EXPOSITION PARK MASTER PLAN

FINAL SUBSEQUENT ENVIRONMENTAL IMPACT REPORT (EIR)
TO THE LOS ANGELES MEMORIAL COLISEUM RENOVATION PROJECT EIR
(STATE CLEARINGHOUSE No. 1990011065)

SEPTEMBER 21, 2020

FIGURE 2.7-2
 Projects Under Consideration

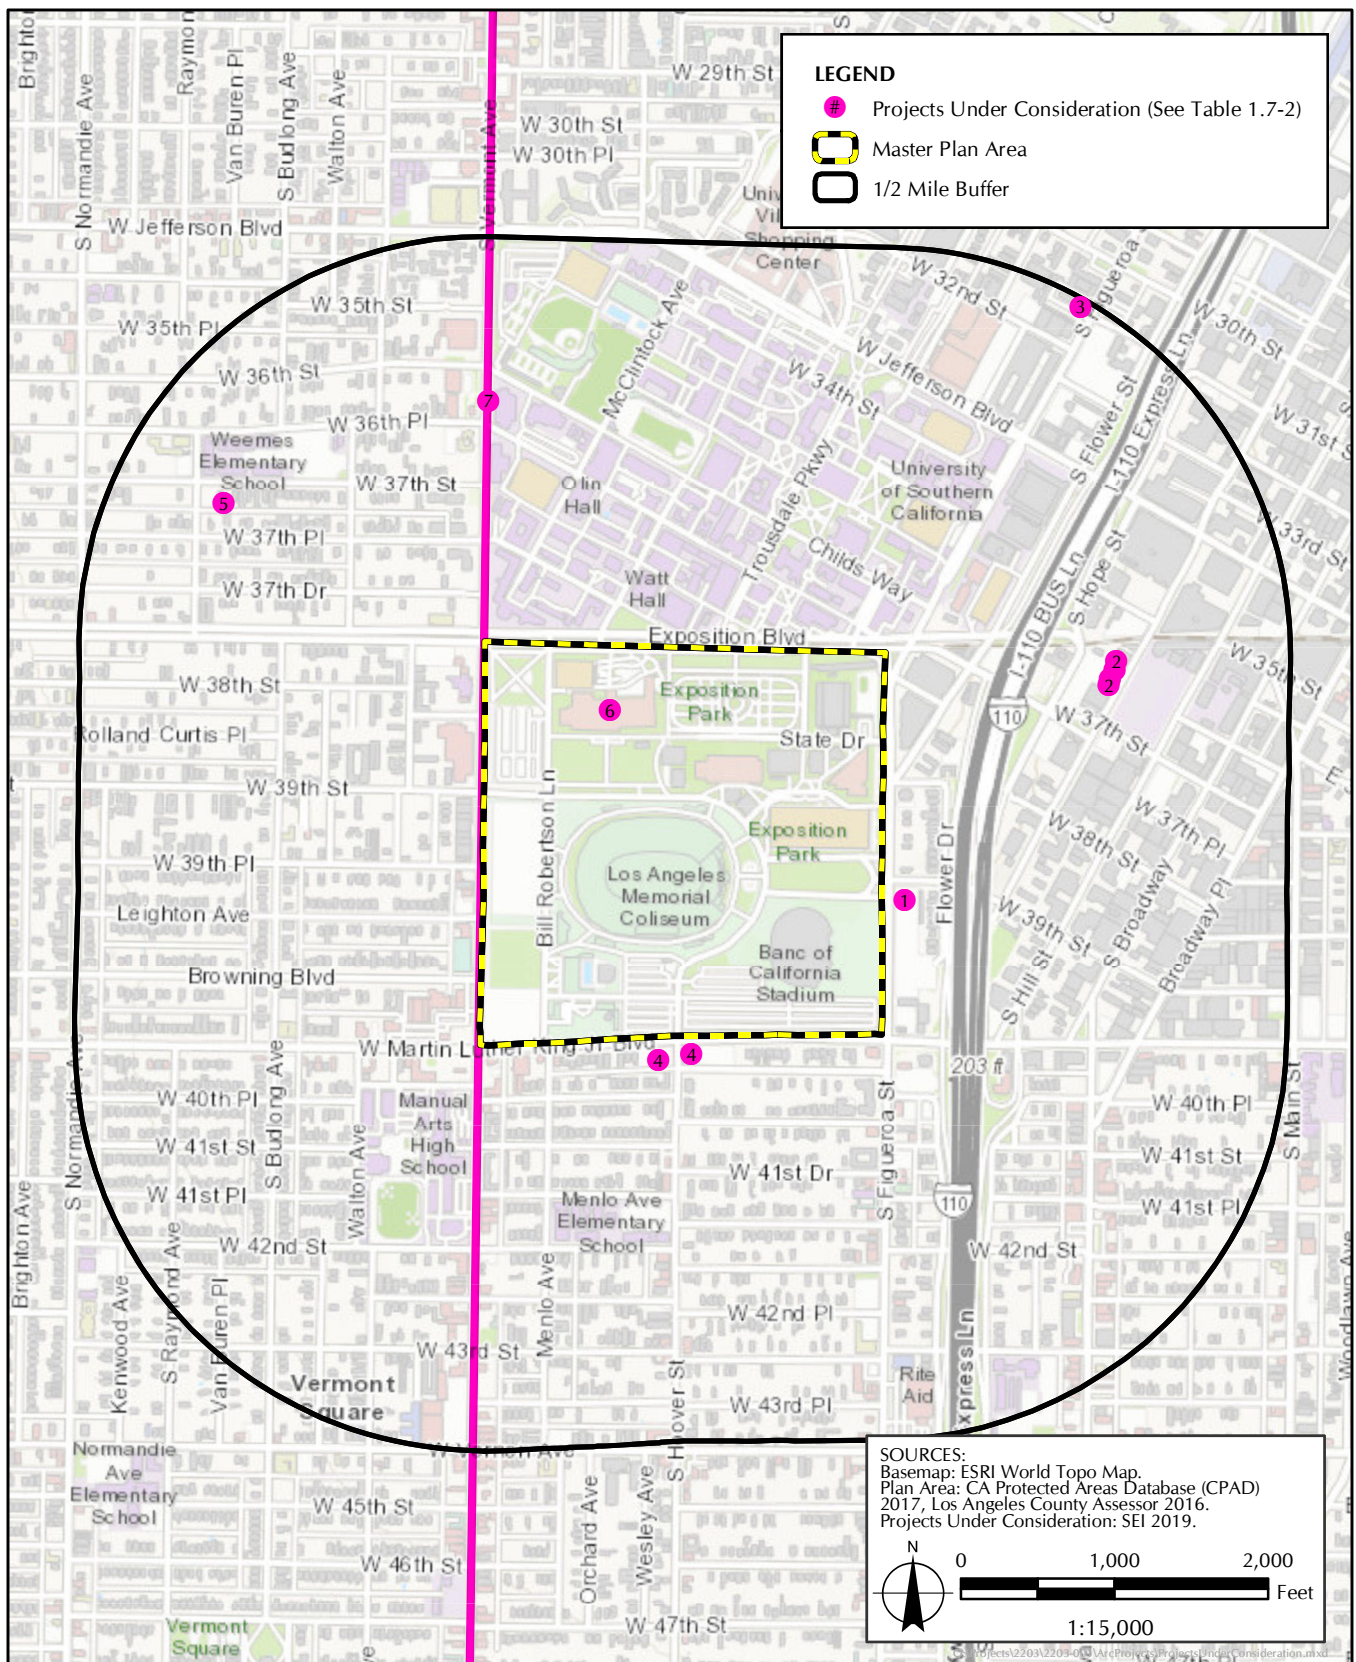
Page 2-26: Figure 2.7-2, *Projects under Consideration*, has been revised to clarify the location of related project under consideration no. 6 and to add the new related project under consideration no. 7.
